Technical Service Bulletin

May 15, 2017

CX65 Bottom Radiator Mount Improvement

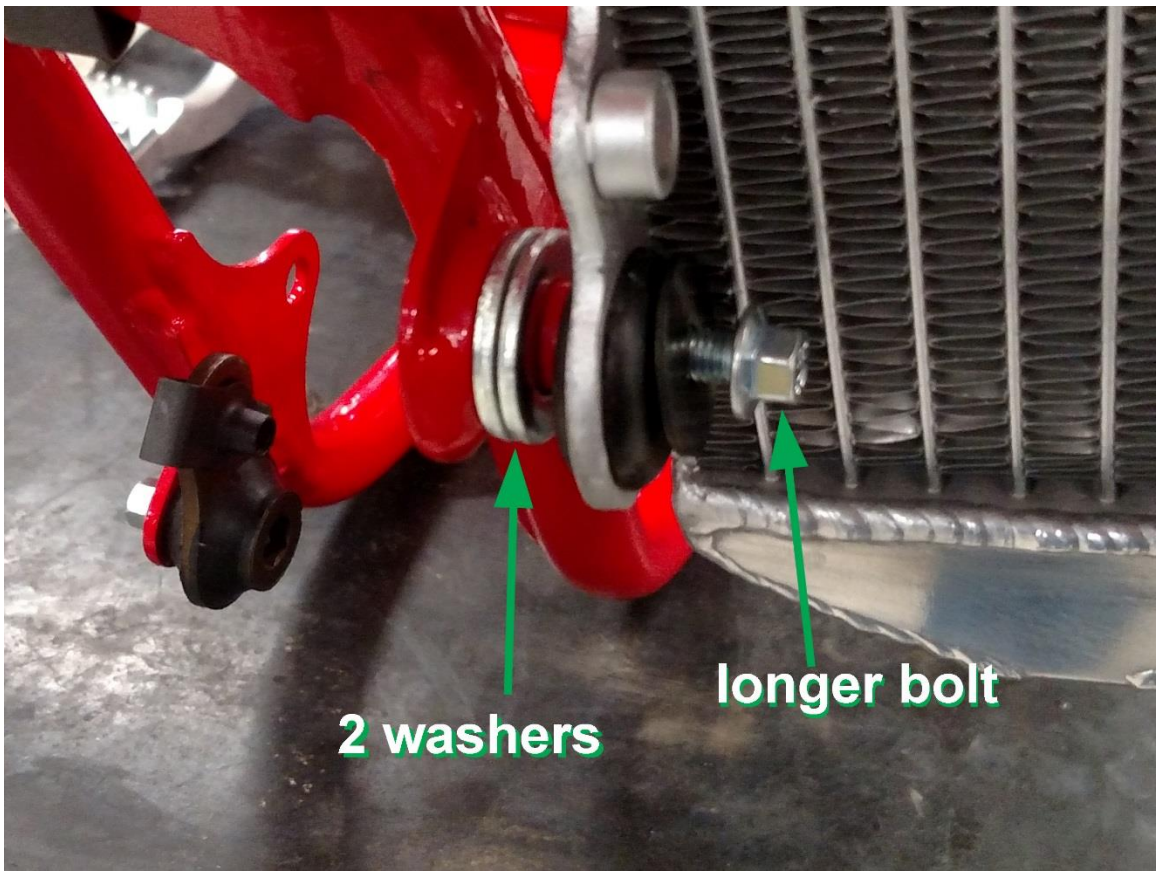
We are asking customers to add two washers (HCWF1202) and a longer bolt (HCBF0620) to the bottom radiator mount on 2014 and newer CX65
